REQUEST FOR PROPOSAL
Kaysville City Council Chambers
&
Police Department Emergency Operations Center
Audiovisual System Replacement

ADDENDUM NO. 3

QUESTIONS AND ANSWERS AND SUPPLEMENTAL EXISTING-CONDITION INFORMATION

Addendum Issue Date: September 22, 2026

Figure 1. Staff Conference Room - overall existing room configuration.

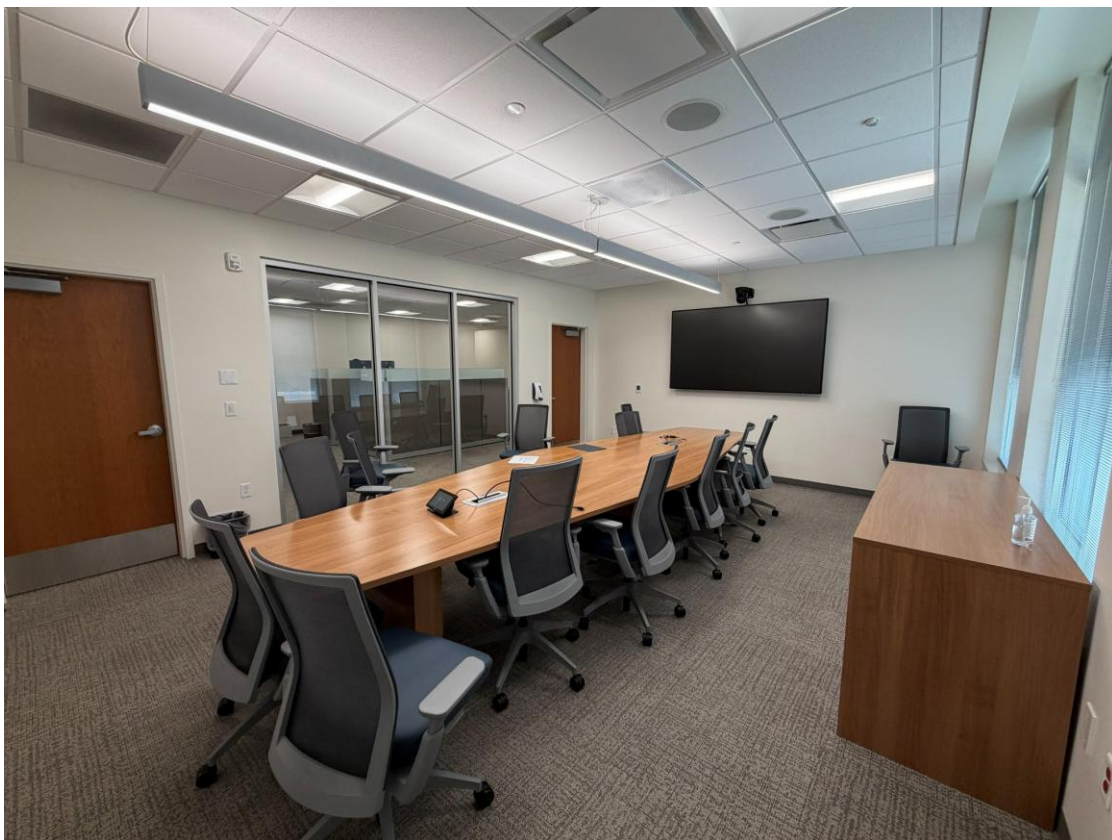
Question 13: Please provide available information regarding the existing Council Conference Room and Staff Conference Room AV systems.

Answer: The Council Conference Room and Staff Conference Room use substantially similar existing AV configurations. The Staff Conference Room includes an approximately 86-inch NEC display, Panasonic PTZ camera, Shure ceiling microphone, ceiling speakers, Crestron touch-panel control interface, table connections, a Crestron DM-TX-4KZ-202-C, a Vaddio AV Bridge Mini, and associated under-table AV equipment. A fixed wide-angle replacement camera is acceptable as provided by the RFP. Supplemental photographs and available building plans are being provided. The City is not providing a separate detailed cable inventory. Proposers remain responsible for verifying existing conditions.
